PRODUCT/PROCESS CHANGE NOTICE (PCN)

PCN #: **U1306-01R1** DATE: **September 12, 2013**
 Product Affected: 6V49205ANLGI
 6V49205ANLGI8
 6V49205APAGI
 6V49205APAGI8
 Date Effective: **July 25, 2013**

ATTACHMENT I - PCN #: U1306-01R1

PCN Type: Die Revision Change

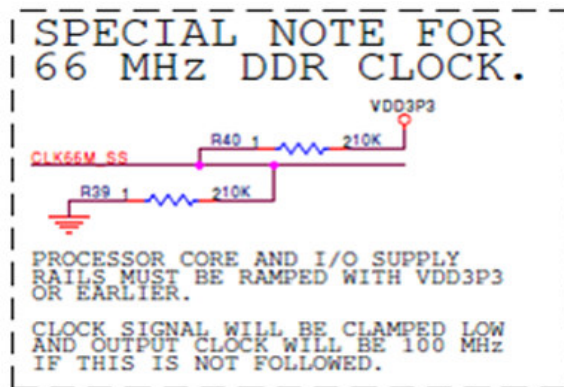
Refer to the additional note added in this revised PCN notice as shown below.
